MASTER DEVELOPMENT DRAINAGE PLAN

CROSSROADS NORTH

Project #18-001
PCD Project #SP 20-207

**MASTER DEVELOPMENT DRAINAGE PLAN FOR
CROSSROADS NORTH
A RESUBDIVISION OF HILLCREST ACRES
EL PASO COUNTY COLORADO**

CHANNEL PARALLEL WITH MARKSHEFFEL ROAD.

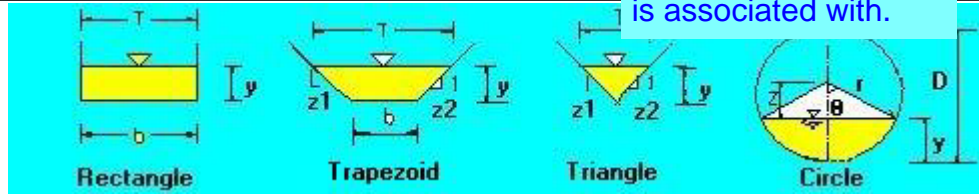
label and reference on the drainage map. Not sure which drainage channel this is associated with.

label and reference on the drainage map. Not sure which drainage channel this is associated with.
COMMENT ADDRESSED. PARALLEL TO MARKSHEFFEL ROAD.

Upstream Capacity at Design Point 27

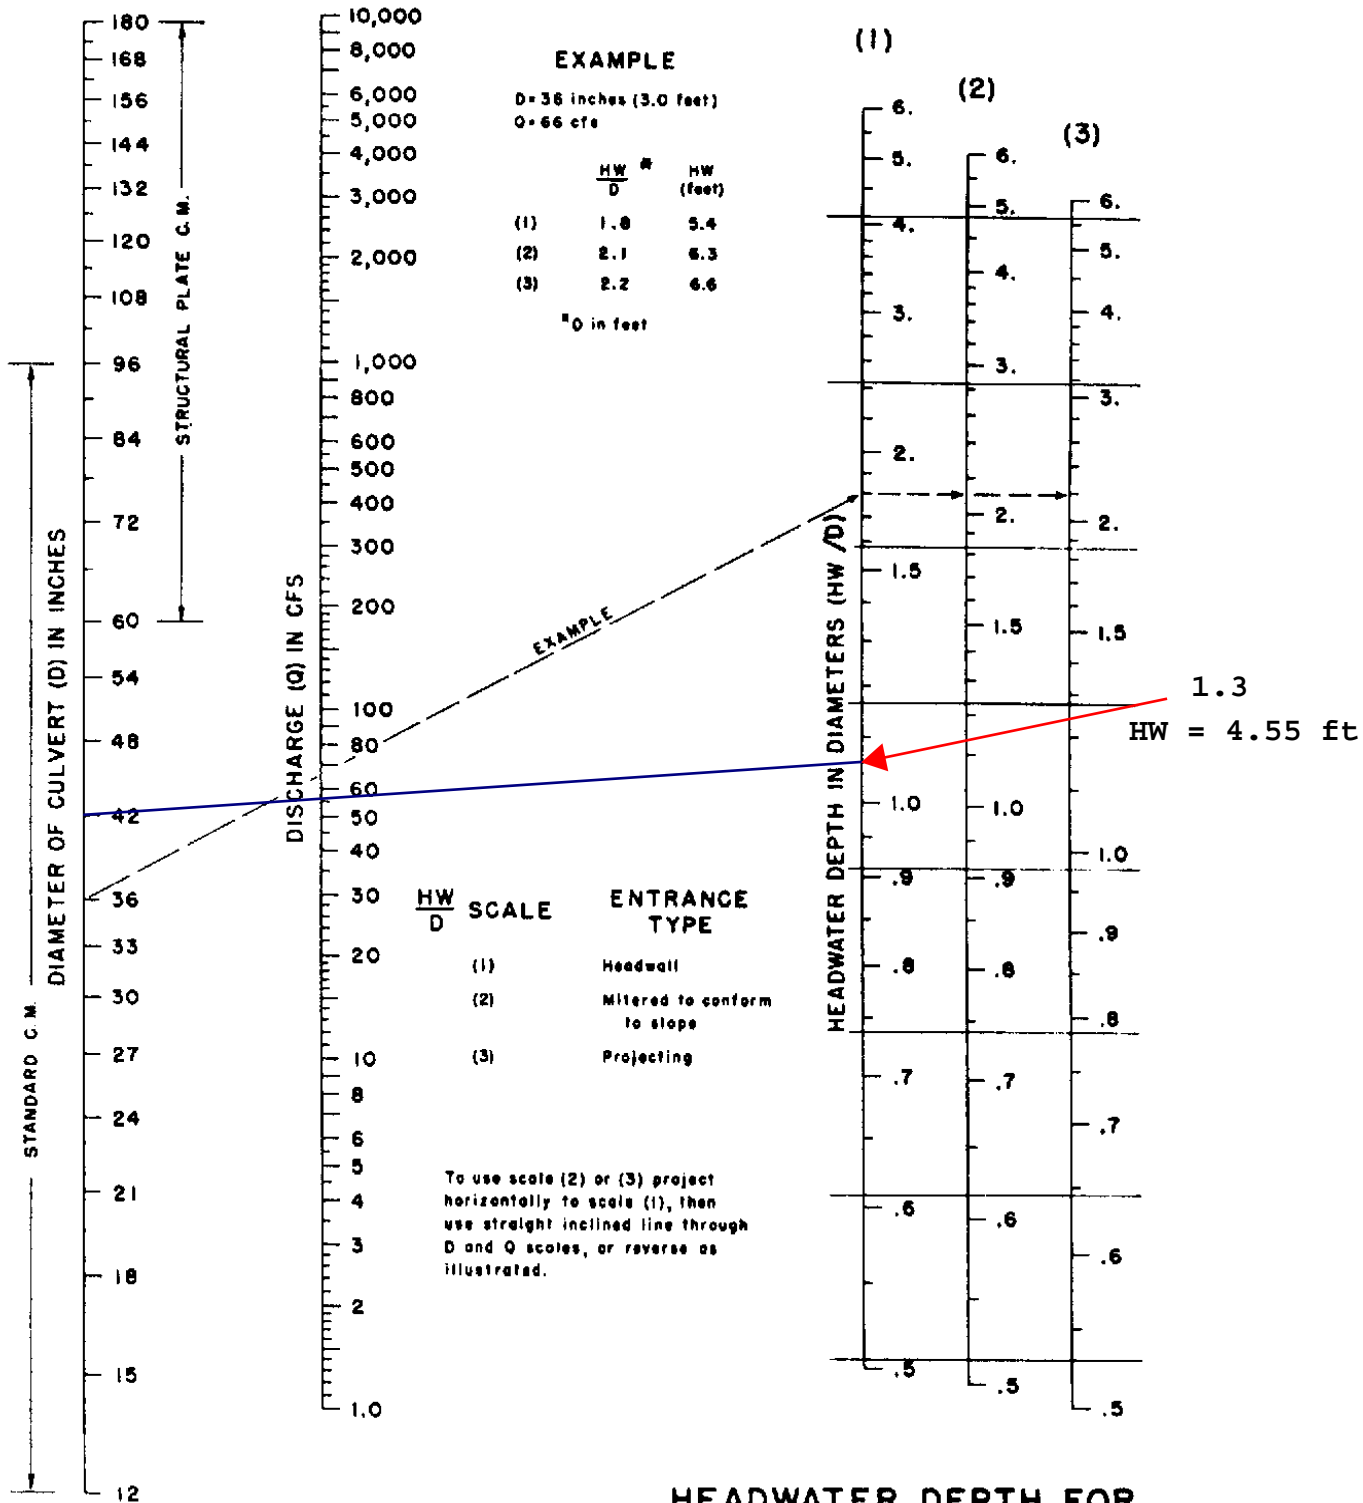
Getting the flow into the pipe may require significantly higher headwater depth. Add at least 1.5 times the velocity head to get the headwater depth or [see my 2-minute tutorial](#) for standard culvert headwater calculations using HY-8.

CROSSROADS NORTH PROPOSED DRAINAGE MAP
DATE SUBMITTED: 03/24/2022
SHEET 1 OF 1

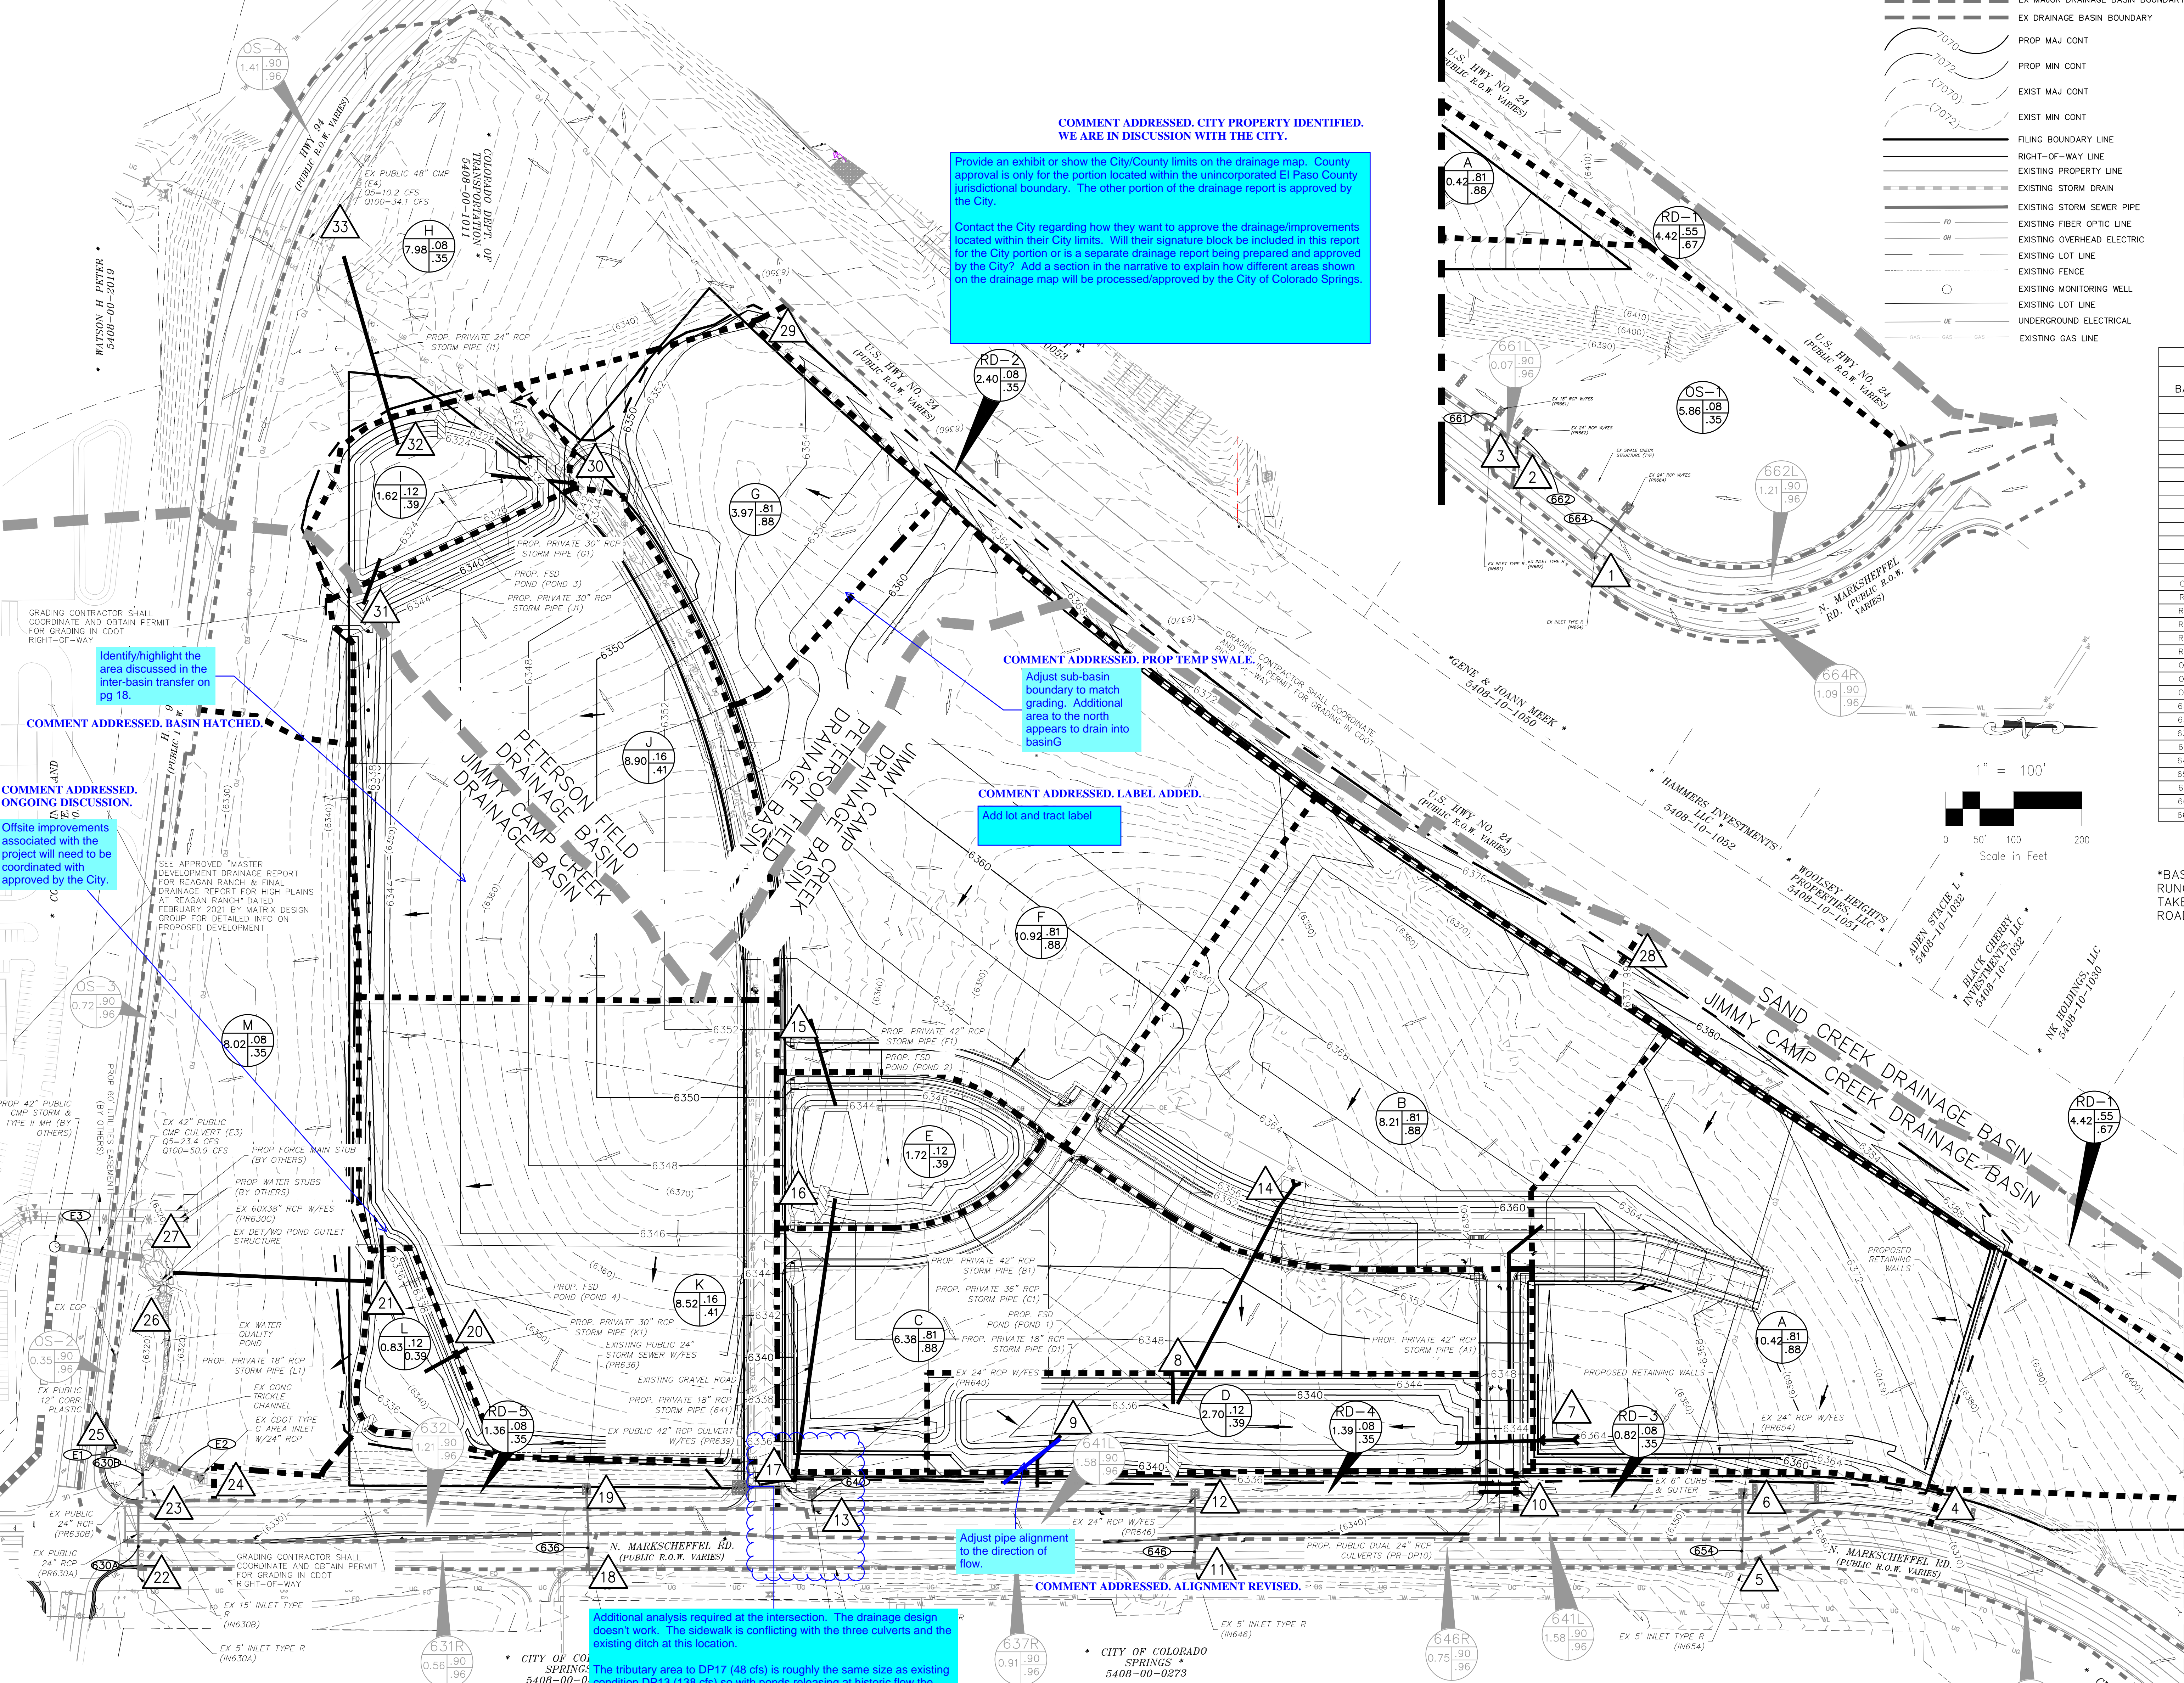
Provide an exhibit or show the City/County limits on the drainage map. County approval is only for the portion located within the unincorporated El Paso County jurisdictional boundary. The other portion of the drainage report is approved by the City.

Contact the City regarding how they want to approve the drainage/improvements located within their City limits. Will their signature block be included in this report for the City portion or is a separate drainage report being prepared and approved by the City? Add a section in the narrative to explain how different areas shown on the drainage map will be processed/approved by the City of Colorado Springs.

Add lot and tract label

COMMENT ADDRESSED. CITY PROPERTY IDENTIFIED. WE ARE IN DISCUSSION WITH THE CITY.

COMMENT ADDRESSED. BASIN HATCHED.

COMMENT ADDRESSED. LABEL ADDED.

COMMENT ADDRESSED. PROP TEMP SWALE

COMMENT ADDRESSED. ALIGNMENT REVISED

COMMENT ADDRESSED. SWALE HAS BEEN PULLED BACK. THE PONDS HAVE DETAINED FLOWS AND DRAINAGE AREA REDUCTION.
